TOWN OF LOS GATOS
PLANNING COMMISSION STAFF REPORT
Meeting Date: October 14, 2015

APPLICATION NO.: Zone Change Application Z-15-001
Architecture and Site Application S-15-018

LOCATION: **485 Monterey Avenue** (southwest corner of Monterey Avenue and Andrews Street)

APPLICATION SUMMARY: Requesting approval to rezone a property from O to R-1D, to demolish an existing office building, construct a new single-family residence, construct an accessory structure with reduced setbacks, and obtain a grading permit for property zoned O. APN 410-16-026.

Recommended Rear Elevation Changes

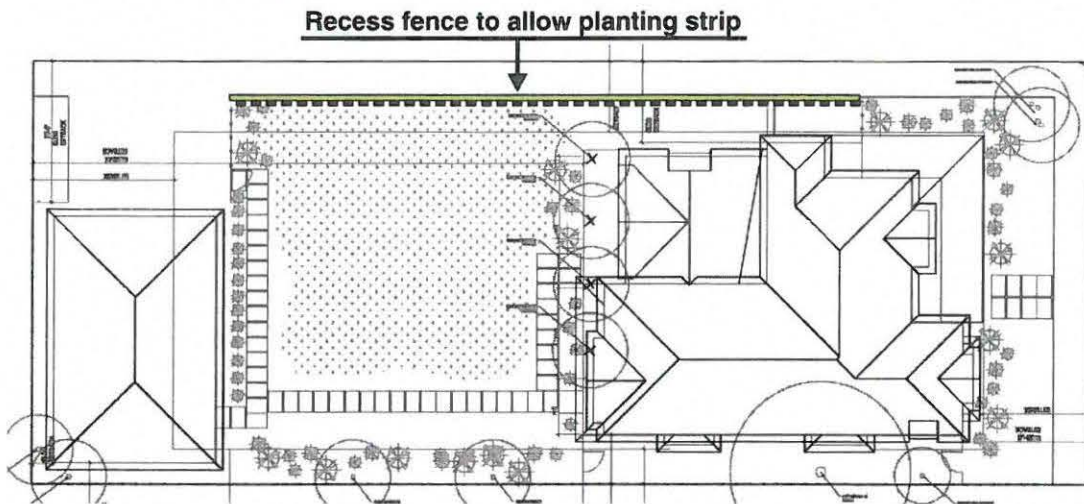
4. The upper arched window at the Master Bedroom on the rear elevation is large, and is crowding the soffit of the gable roof.

Recommendation: Reduce the size of the arched window to allow more room between the window and the gable eaves.

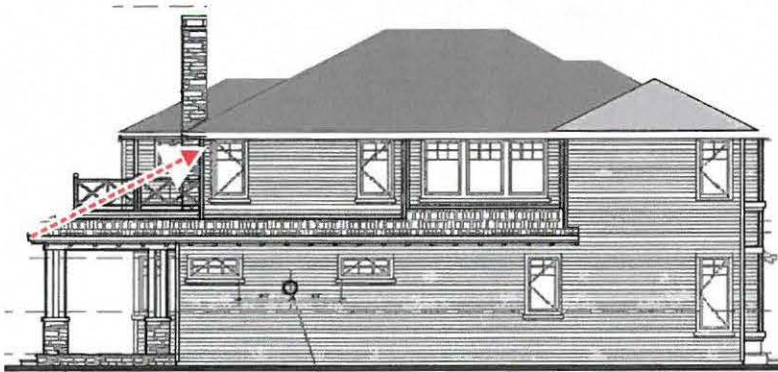
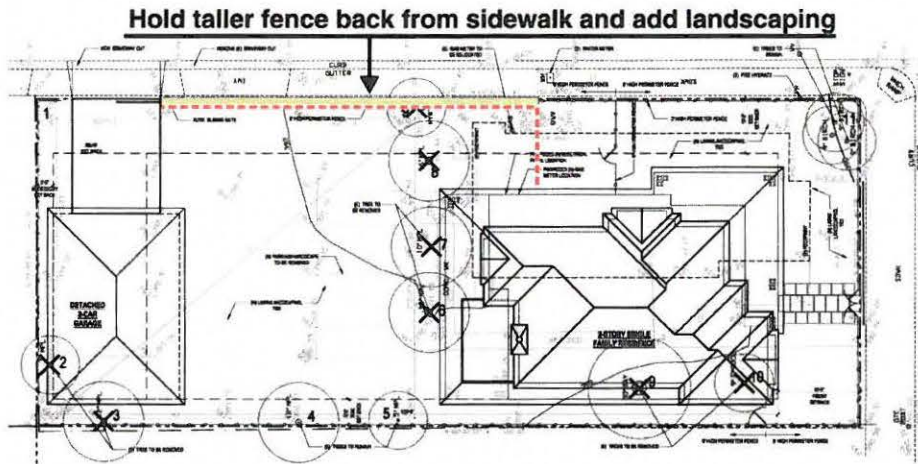
The rear second floor deck issue presents more of a challenge. To eliminate it totally would result in a roof that would extend up to the eave line, blocking out all windows on the rear elevation, as shown on the diagram below.

To keep windows on this facade would require either a flat roof in the deck area or the extension of the Master Bedroom rear wall outward to approximately the line of the Master Bath. Since the deck would be mostly providing visual exposure to rear or side yards, an alternative approach could be to evaluate the existing landscaping, and add additional evergreen buffer landscaping to the side and rear of the lot, as needed.

June Elevation
SOUTH ELEVATION

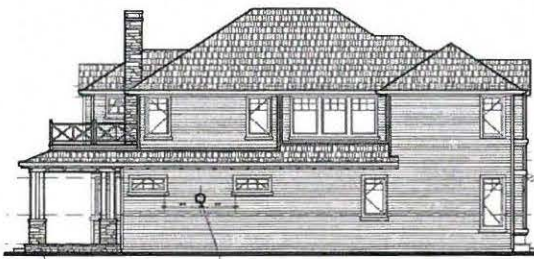
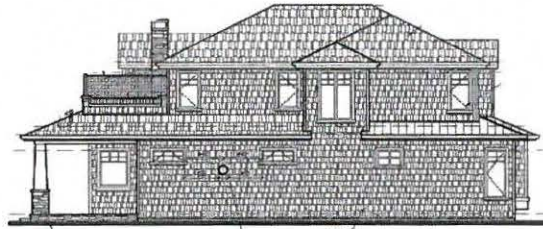
The changes that have been made in the design have reduced the overall height and bulk of the structure, and have simplified many of the awkward roof relationships of the earlier design. The elevations reviewed for the June letter are shown below along with the current revised elevations.
